# RUSSELL COUNTY

## *LANDFILL DEVELOPMENT FEASIBILITY (MOSS III LANDFILL)*

# SITE EVALUATION

# SITE EVALUATION

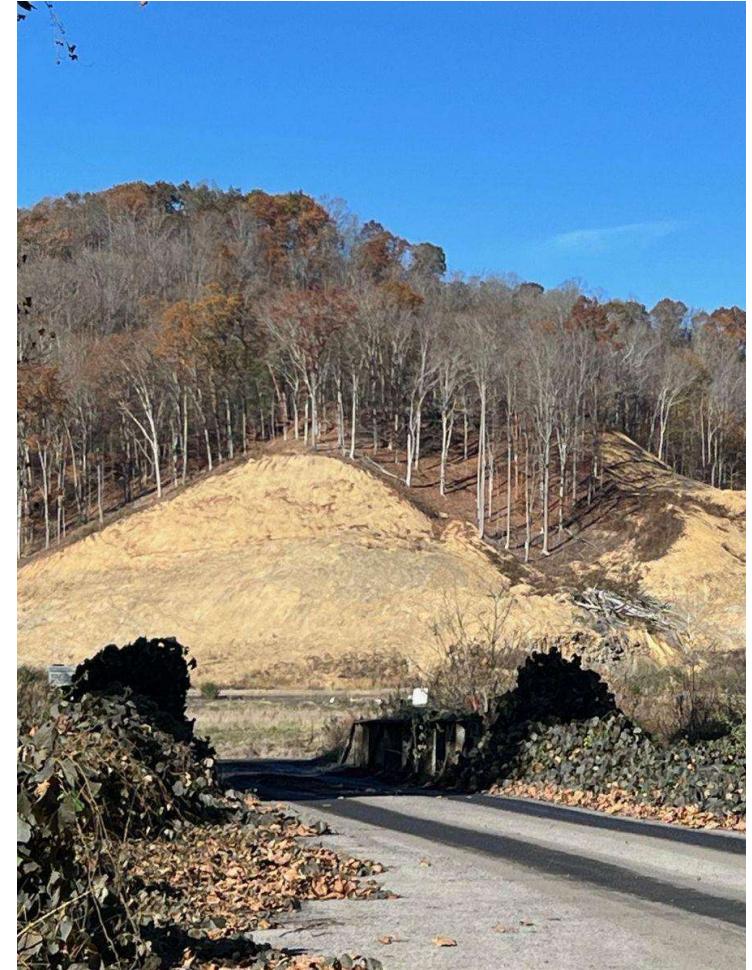
- Remove unsuitable material
  - Coal fine/soft soils
  - Acceptable firm foundation
- Evaluate the suitability of coarse coal refuse
- Detailed Stability Analyses
  - Natural soils
  - Coarse coal refuse
  - Existing coal refuse dam embankments
  - Proposed liner system
  - Landfill waste
